WPCLF 2025-26

Columbiana County Health District

Site Address: 810 Maple St. Parcel #: 18-02055.000 Township: Columbiana FA

810 Maple St., Columbiana – Septic install

septic
810
Jorge
Deck
well
10/29/25
not to
scale
maple
sewer

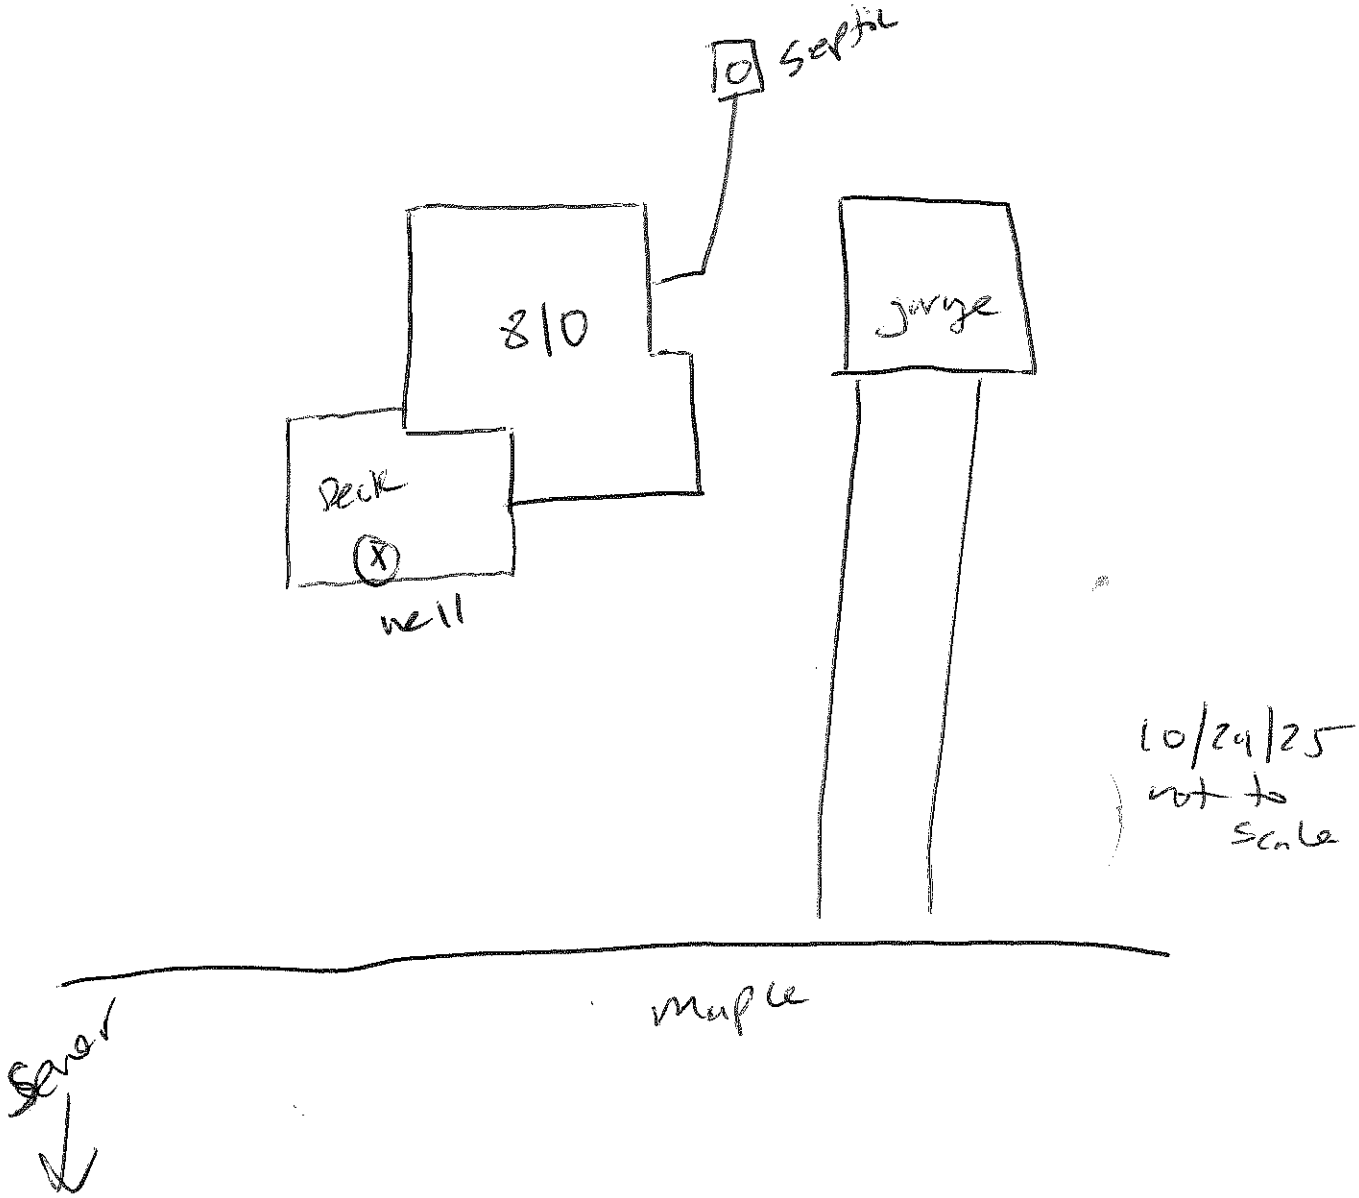
All plumb tied into septic.

No discharge point - need discharge field - See attached septic system attached per code.

☒ Based on the information submitted, this lot is not suitable for an on-lot Sewage Treatment System. NPDES permit is required from the OEPA for approval of an off-lot discharging system.

18-01191.000
Water Well
18-02055.000
Existing Tank
Discharge Field
18-01190.000
Discharge line with gravel pit outlet
18-02054.000

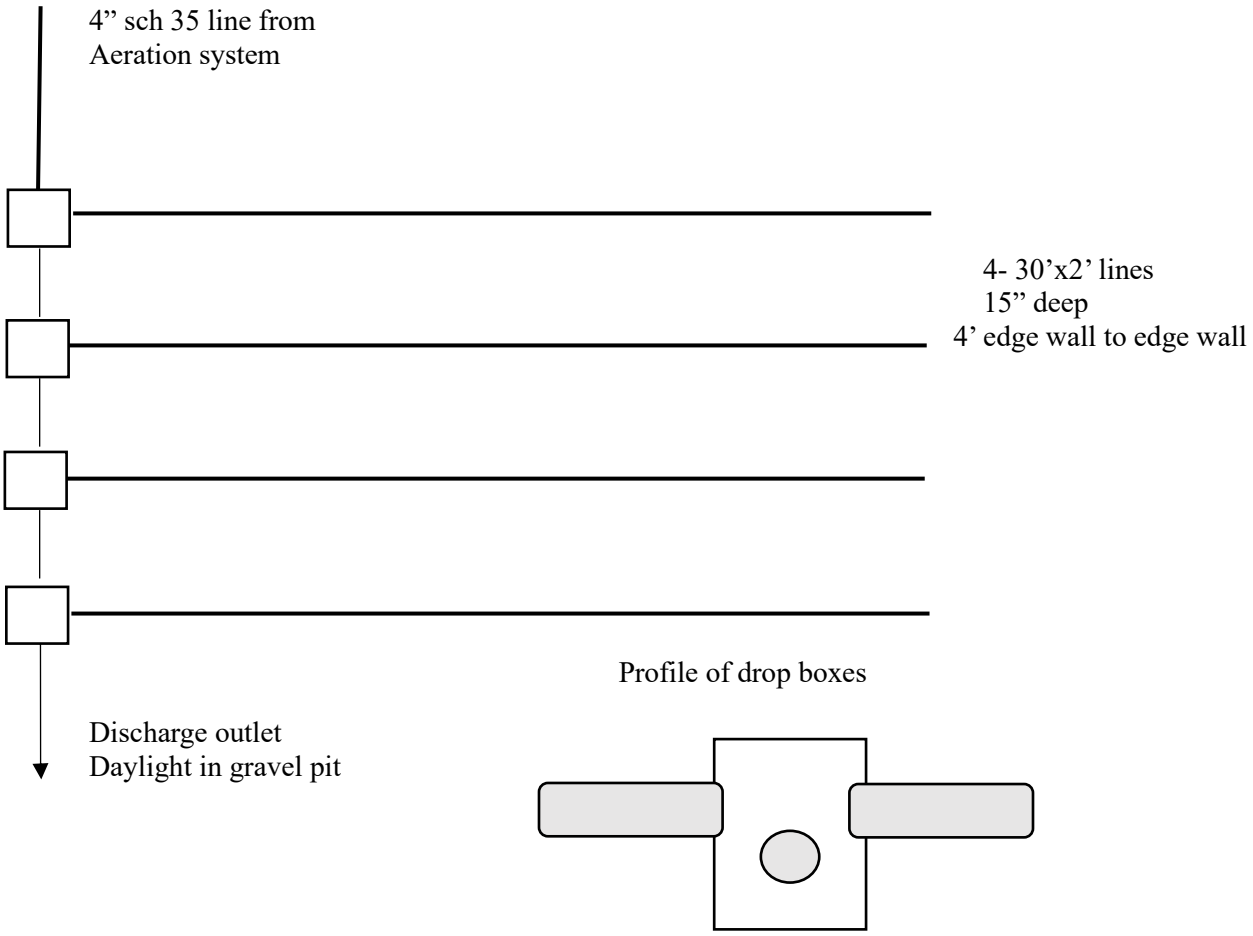
- An NPDES approved aeration system must run into a discharge field then discharge in a surface gravel pit on this parcel. See diagram
    - 4- 30'x2' leach lines 15" deep- Pipe and gravel or chambers are acceptable
    - 4 drop boxes to be installed at each line for distribution
    - Discharge line will feed from the 4th drop box when all lines have been filled
    - Discharge line will be 4" perforated PVC, the pipe and 2' past the daylighted outlet will be graveled (gravel pit 3' long x2' wide 4" deep).
- NPDES permit required $200 fee to be paid to OEPA
- Bid must include a 5 year service contract for the aeration system
